REF: VARIANCE REQUEST FOR LU BOW ADDITION, 1108 ALVARADO NE J-18 RECEIVED NOVEMBER 20, 1985

Drainage/Grading Variance Request for Lu Bow Office Addition, 1108 Alvarado N.E., J-18-Z. - 930

FEMA MAP #30

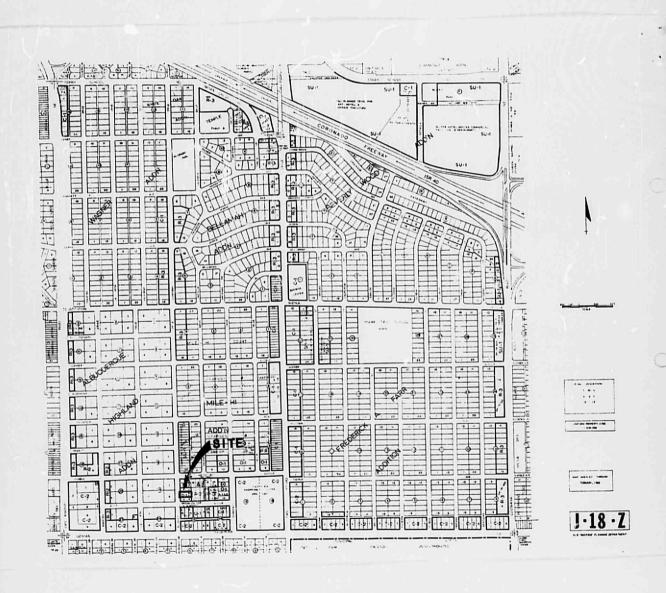
The attached FEMA Map (#30) shows no flood hazard areas near the site. The closest flood hazard area, located about 1/2 milr to the north at the intersection of Constitution and San Mateo, will not be affected by the Lu Bow office addition.

The above variance is approved for Hydrology to sign-off on the Building Permit. We are approving the variance because of the following:

- 1. Minimum area of roof area.
- 2. Building construction over impervious area.
- 3. Field inspector did not observe any drainage problems.
- 4. Not in a flood zone.
- 5. Roof drains safely to public R/W.
